Engineering review on the final closure of Saemangeum Dike

**Report EX 5192
Release 2.0 – Draft Final Report Version
September 2005**

Project	Engineering review on the final closure of Saemangeum Dike
Report title	Engineering review on the final closure of Saemangeum Dike
Client	KARICO
Client Representative	Dr Daesu Eo
Project No.	MCR3824
Report No.	EX 5192
Doc. ref.	EX5192 - Saemangeum Dike-R 2_0.doc
Project Manager	Jonathan Simm
Project Sponsor	Paul Sayers

HR Wallingford has commenced an engineering review on the Final Closure of Saemangeum Dike. This draft final report represents the completion of the second phase of studies by HR Wallingford and is issued for review by KARICO and discussion with their representatives during meetings planned in Ansan during the second week of October 2005.

Figure 2.3 Arrangements for final closure as provided by KARICO

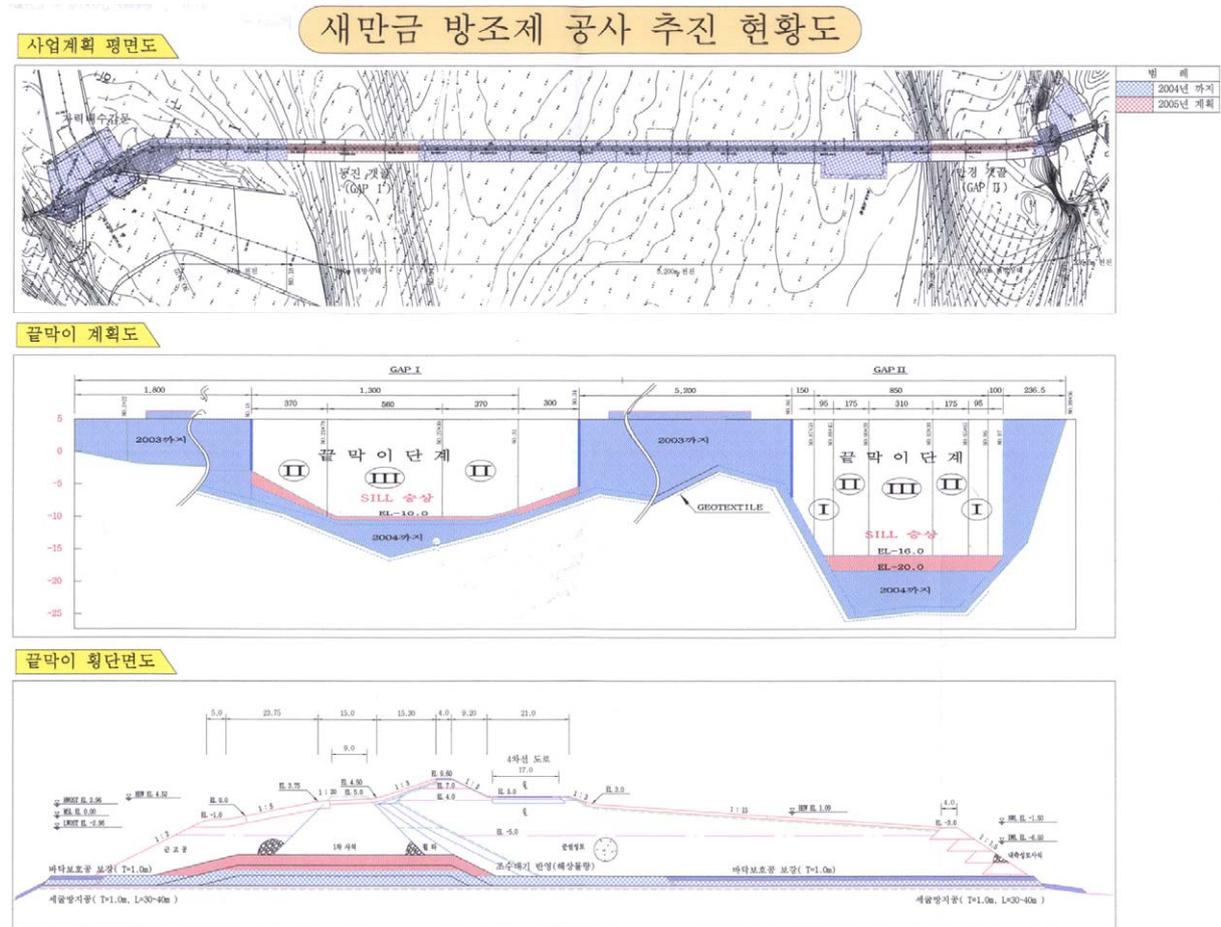
Figure 2.3 provided by KARICO explains the various stages in the closure process in further detail. The waiting periods have been selected to coincide with the highest spring tides when currents will be at their maximum and successful placing of stone into these currents will be difficult.

Figure 3.3 Relationship between gap centre speed and water level difference across gap, tests 6, 7 and 9

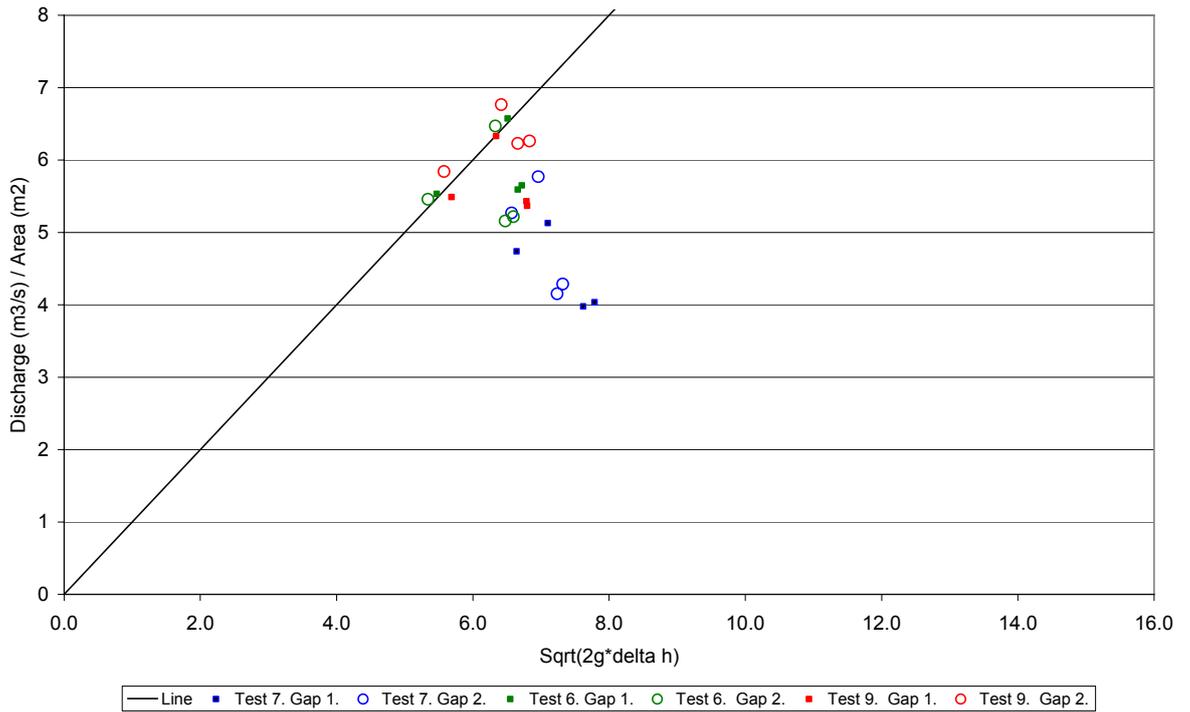
To investigate whether the model conforms to such a formula the results of the HR model for three stages of closure were tested for obedience to this formula. It was found (Figure 3.3) that the formula was approximately obeyed but that for a wide gap the coefficient μ was about 0.7 and it grew as the gap narrowed up to a maximum value of about 1.1. These results are as might be expected although the manual suggests that generally a coefficient μ of the order of 0.9 is appropriate. In the context of horizontal closure it is also suggested that values rising to 1.3 or so may be possible as closure proceeds.
